CITY OF VANCOUVER

POLICY REPORT DEVELOPMENT AND BUILDING

TO: Vancouver City Council
FROM: Director of Planning
SUBJECT: CD-1 Text Amendment at 322 Davie Street (Opus Hotel)

PROPOSED FORM OF DEVELOPMENT: ROOF PLAN | 4.5

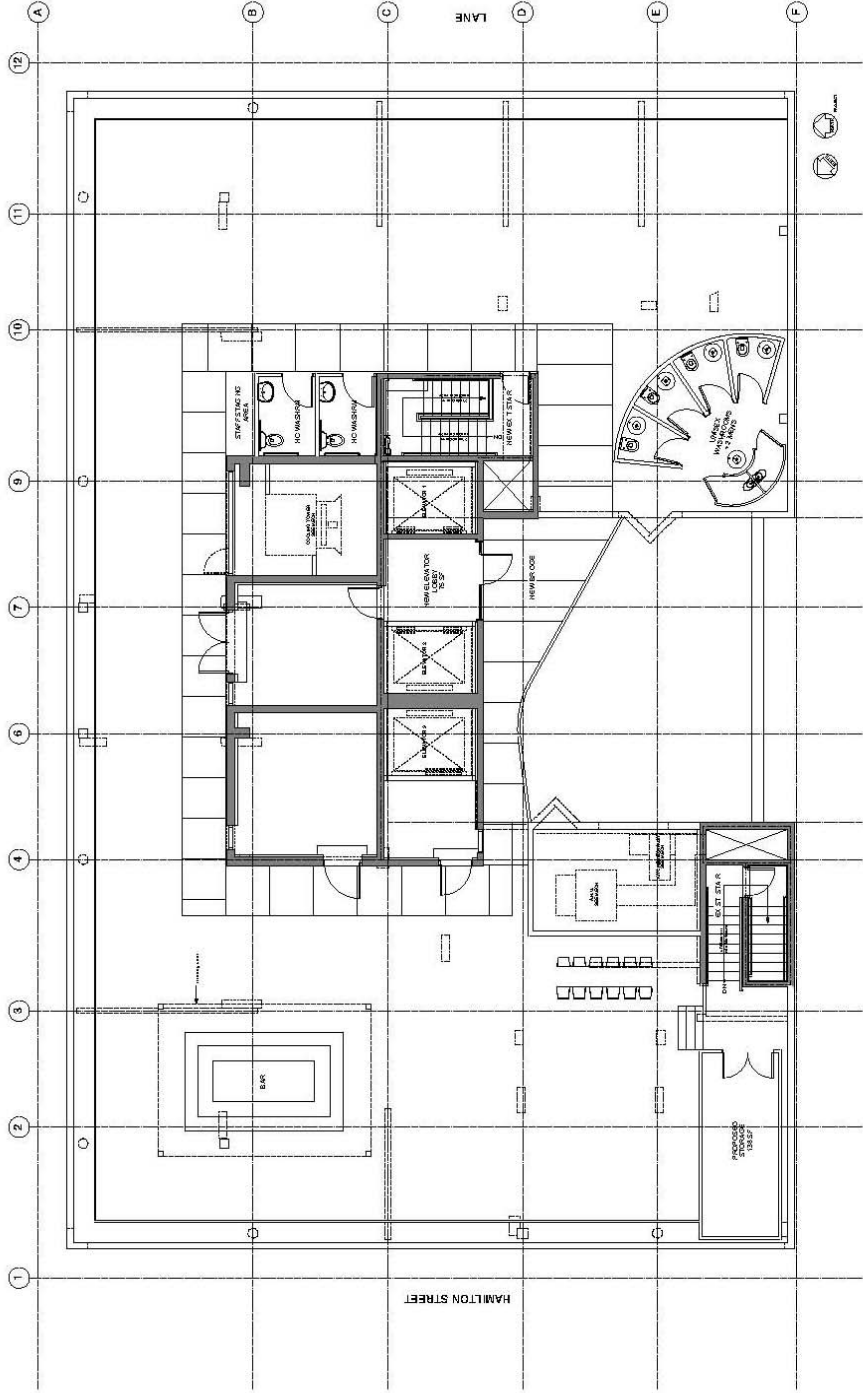
Form of Development: The open-air restaurant sits on a raised platform above the roof deck to allow existing ductwork to be redirected to a mechanical enclosure located at the rear. A 5 foot high glass screen is proposed around the building perimeter and is set back from the parapet to reduce visibility from the street. The rooftop is divided into three functional areas: the area on the Hamilton Street side with approximately 135 seats including a bar area; the area on the south-facing side with approximately 86 seats; and the area on the Davie Street side with approximately 29 seats. It is intended that most of the fitments including the tables, chairs and removable umbrella-like structures will be dismantled and stored during the winter. Permanent structures include washrooms, a new exit stair and elevator access to the roof level.

- Design development to increase the height of the glass guard to reduce overlook from adjacent properties.
- Consider adding more greenery to the roof to improve screening of overlook.

- The roof will need to be designed and fire rated for the intended occupancy.
- Two 1 100 mm wide exit stairs typically provide a maximum capacity of 274. The applicant should review their exit capacity. They can not have an occupant load greater than their exit capacity.
- The project is a vertical addition of another storey. This may require the building to incorporate high-rise measures.
- The Fire Fighter's elevator is required to go to the restaurant level.

The applicant would have to apply to this office for an occupant load certificate and update the Fire Safety Plan. The area in question would require two means of egress from the roof. The applicant should meet with this office to discuss any other fire safety related issues.

- (i) design development to reduce overlook from adjacent properties;

Note to Applicant: Consider view exposures from all adjacent properties, screening as appropriate to reduce visibility. Materiality, colour, texture and height of screening should be carefully considered to present an attractive, yet unobtrusive visual buffering from adjacent sight lines. The screening should be setback sufficiently from the existing parapet so as not to be visible from the street or detract from the existing roofline.

- (ii) design development to include a landscape treatment, adding substantially more greenery to the rooftop;

Note to Applicant: Landscaping will help to provide visual and acoustical buffering between neighbours and improve overlook. Landscaping should consider seasonal changes and be well maintained throughout the year.
